UNIVERSITY OF MINNESOTA
HEALTH SCIENCES EXPANSION

MEETING NOTES

SUBJECT: CODE REVIEW
PRESENT: GUS SCHEFFLER, KEITH JOHNSON, ART YOUNG, KURT ROGNESS
TAC JOB: 70048 - UNIT F
DATE: 9 NOVEMBER 1971
BY: KURT ROGNESS

SUBJECT: CODE REVIEW

PARTIAL
Floor Plan (1/16" = 1'-0")
(LEVEL 4)

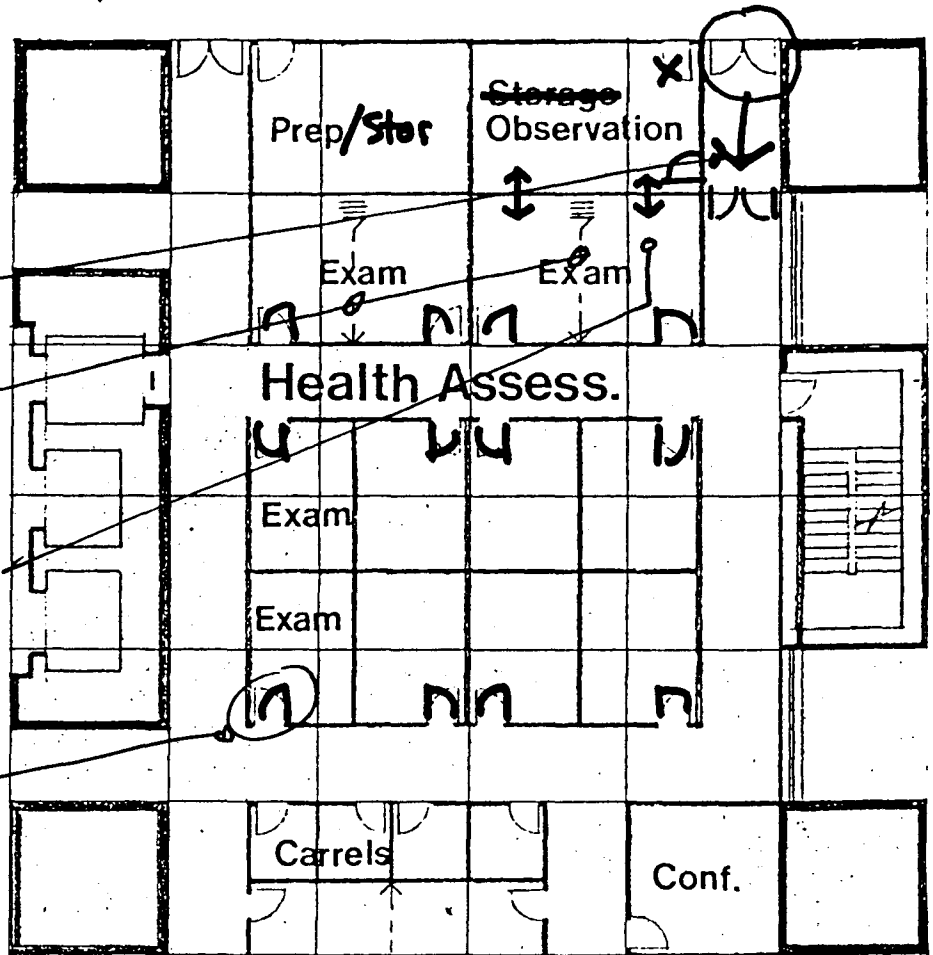
-
1. After TAC/HSAE presented the attached partial plan of Level 4 and summary of spaces assigned to Health Assessment, the following comments were made:
 - a. Door swings in exam rooms should be reversed to improve conditions for privacy within the rooms.
 - b. Access to the observation room should be directly from the corridor rather than from the nursing skills laboratory.
 - c. To comply with code requirements which limit the length of dead-end corridors to 20 feet, the doors to the skills laboratory must be relocated as indicated.

4. Glazing for the windows between the observation and examination rooms, and lighting within the rooms, should provide the capability to observe from either side. Windows should be approximately 4 feet wide.

5. The observation room should be furnished to provide for children's play or adult conference, and the storage function as indicated in the plan either should be relocated or minimized by using enclosed cabinets. Large items can be stored with other equipment in the nursing skills laboratory support area.

RELOCATE DOORS
(ACCESS + CODE)

PROVIDE TWO-WAY
OBSERVATION CAPABILITY
(2 EXAM ROOMS)

TAC/HSAE will verify details of lighting and glazing specifications.

Nursing/HSPO will complete a list of furnishings for this room, based on its dual use as observation/teaching and playroom/conference.

Floor Plan (1/16" = 1'-0")

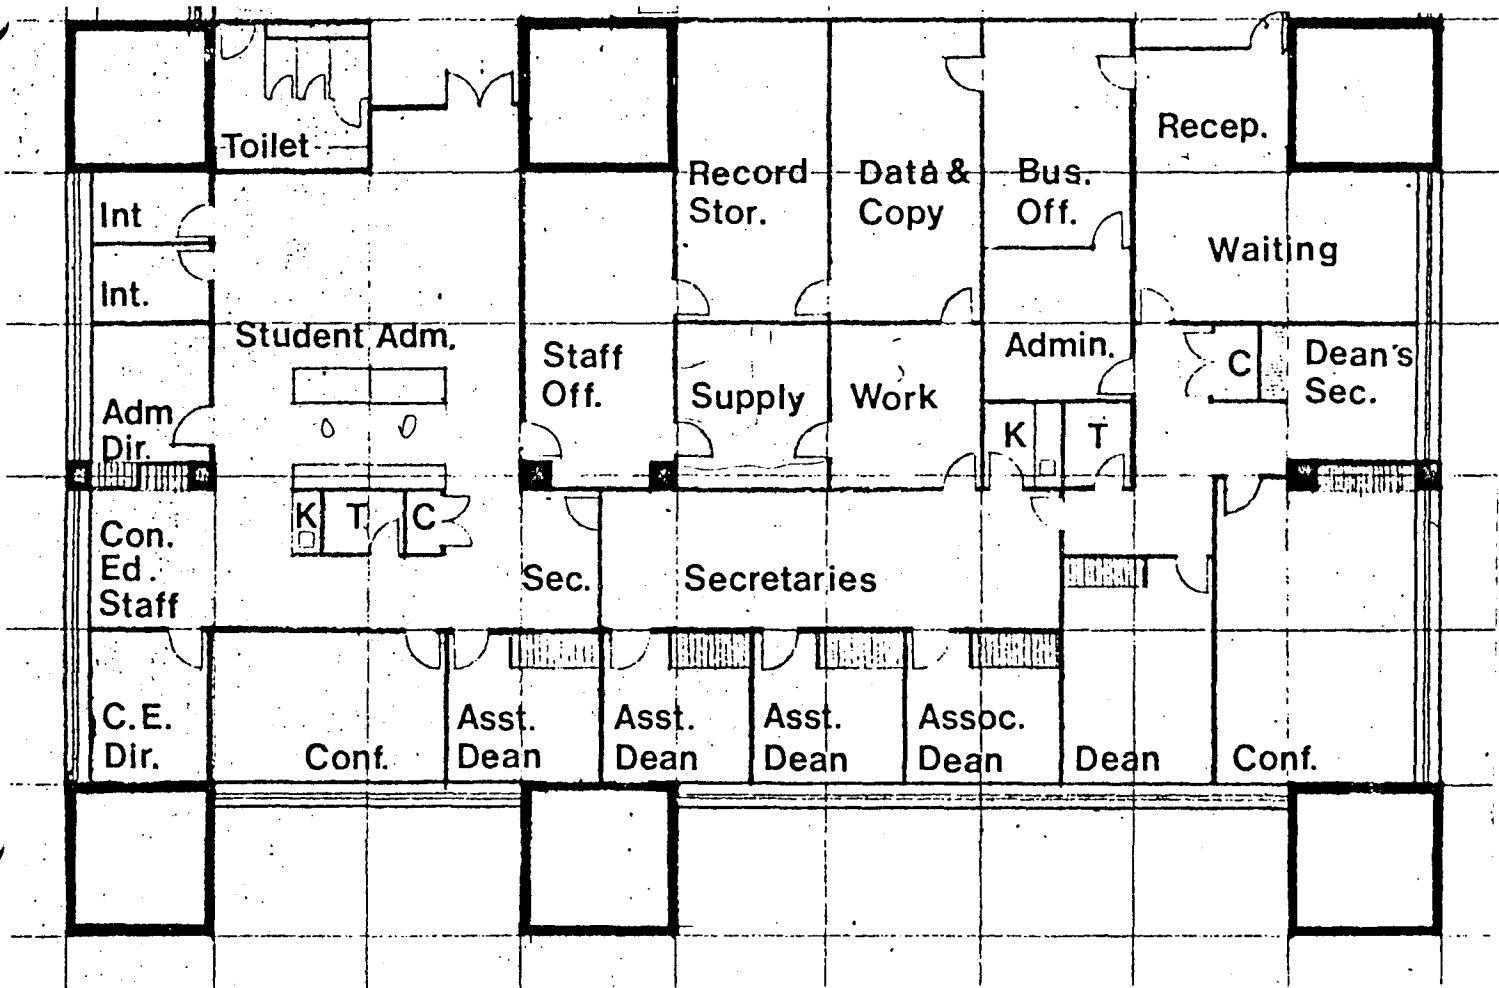
1. After TAC/HSAE presented the attached partial floor plan of Level 5 and summary of spaces assigned to Nursing Administration and Admissions, the following comments were made:
 - a) The Dean's office and conference room should be reversed for two reasons: circulation between the reception or waiting area and the Associate or Assistant Dean's suite should not pass the door to the Dean's office; and only visitors to the Dean should pass through the office to the Dean's secretary.
 - b) The office for the Business staff is to contain 3 desk stations; the office for the Administrative Officer should be relocated to the exterior wall; and the waiting/reception space can be reduced (to accommodate 3-4 chairs).

- e) Reference was made to other plan studies for the Admissions and Continuing Education suites. These were developed by Kurt Rogness from previous meetings but not included in the present plans. TAC/HSAE will verify former plan arrangements and incorporate details into revised drawings.
